# Addendum Number 2

## Issued 5/6/2024

### Franklin Active Adult Center (AAC)

## **ADDENDUM NO. 2**

### 1 ONE-LINE DIAGRAM

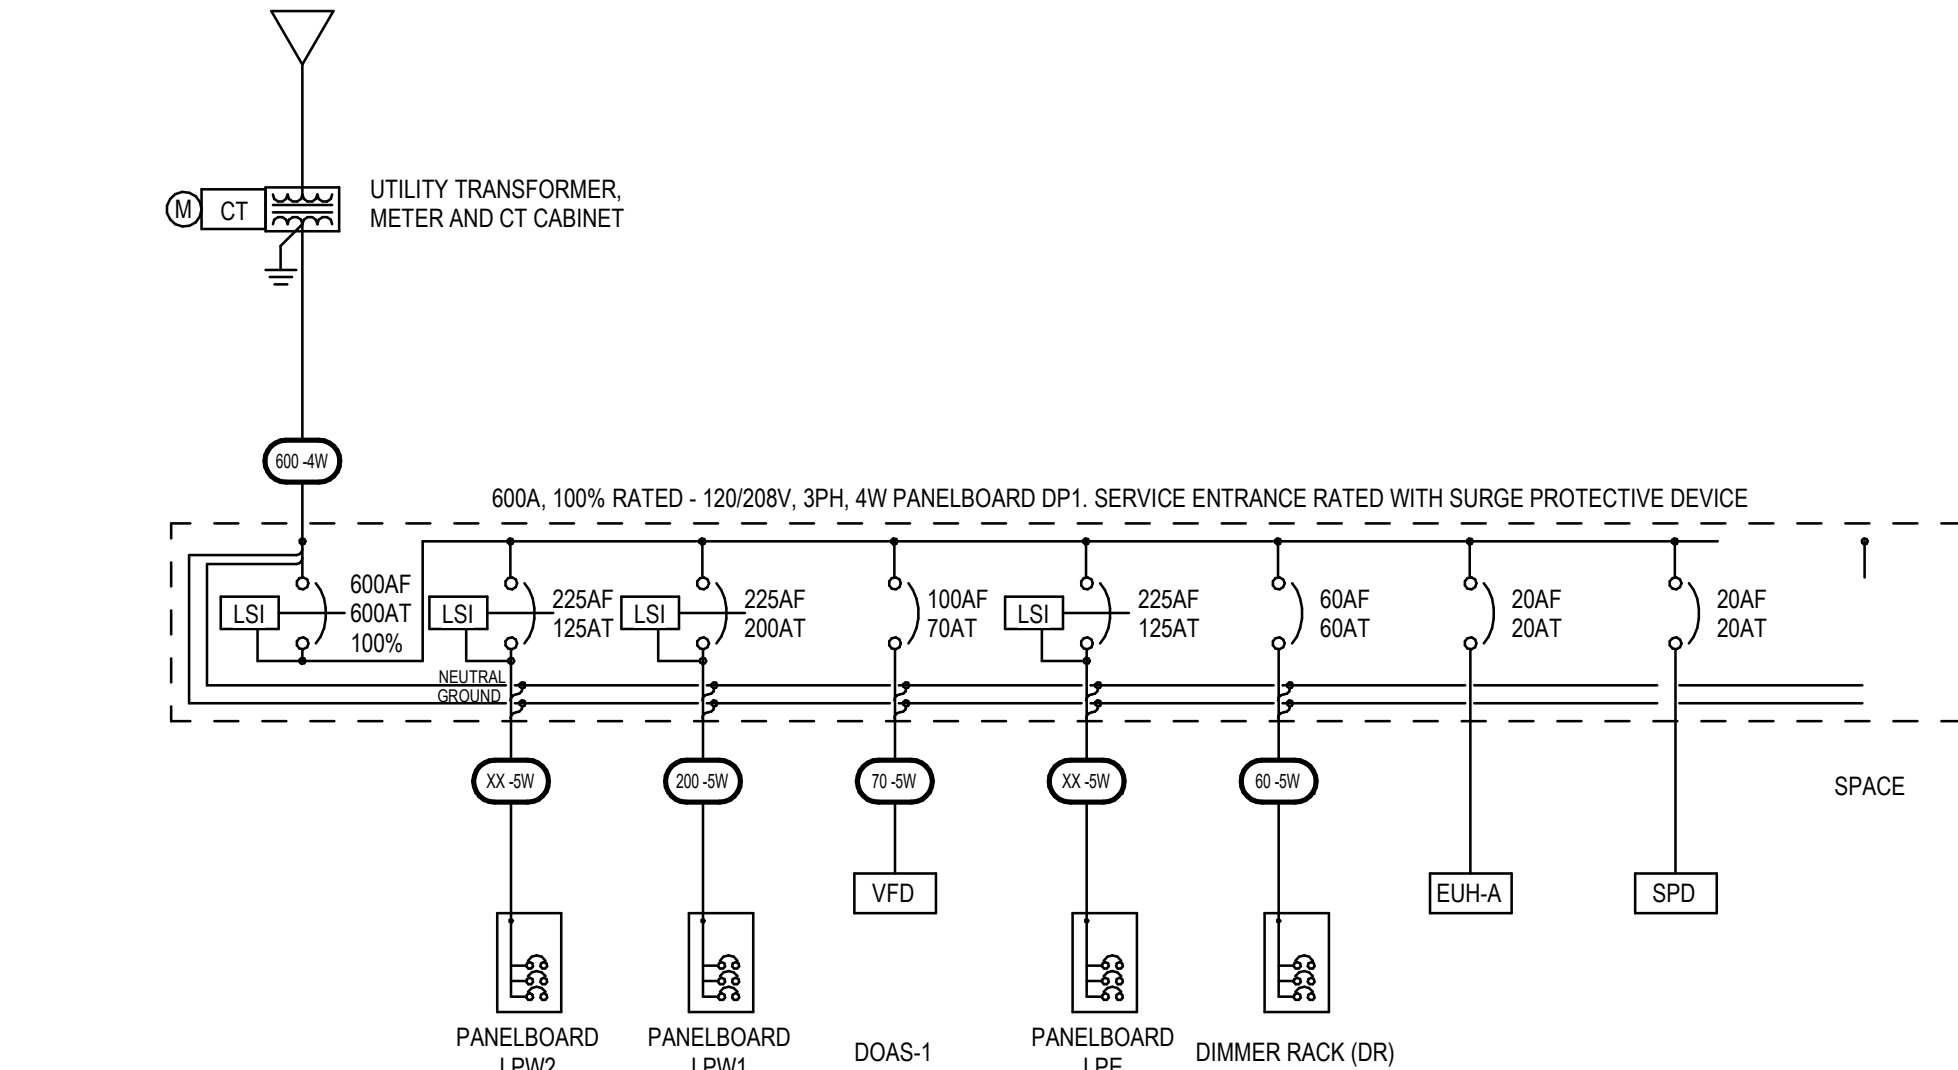
- Item No. 19** Sheet A703: Add a mid-rail to doors 6 and 6A (For panic hardware installation).
- Item No. 20** Sheet A806: Interior Elevation 16 – Dressing Rooms. Add under counter support brackets at ends and midpoints.
- Item No. 21** Sheet E701 attached: Electrical One-Line Diagram
1. Revised Fire Alarm Riser Diagram to clarify fire alarm system shall be a voice/strobe evacuation system.
  2. Revised Note 2 in the Fire Alarm Riser Diagram to indicate the microphone shall be provided at the Fire Alarm Annunciator Station.
- Item No. 22** Sheet E801 attached: Luminaire Schedule. Add Acceptable manufacturers as shown.
